Subject: Relocating Roof Mounted Antenna

Models Years Affected: 2016 - Beyond

Models Affected: Chevrolet Express/GMC Savana
Cut-away vans equipped with OnStar® (RPO UE1)

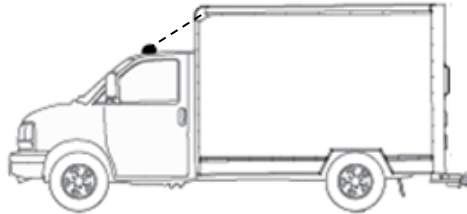
Vehicle models that are listed above and equipped with OnStar (UE1) and a roof top antenna may notice under certain conditions reduced system performance when the vehicle is upfitted with a service body that has a higher elevation than that of the OEM roofline (see example below).

To optimize performance of both the cellular and GPS systems in all areas throughout the U.S and Canada, it is **RECOMMENDED** that when installing a service body which is higher than that of the OEM roofline, the antenna be relocated to a location where the cellular signal is not obstructed.

BE FURTHER ADVISED: Vehicles with service bodies that overhang or cover the roof mounted antenna should have the antenna relocated to enable the noted system(s) to operate properly.

A kit is available (RPO = G7K) for ordering at the time of vehicle. This kit will include an additional antenna, an extension cable assembly (25ft), metal grounding plate and instructions.
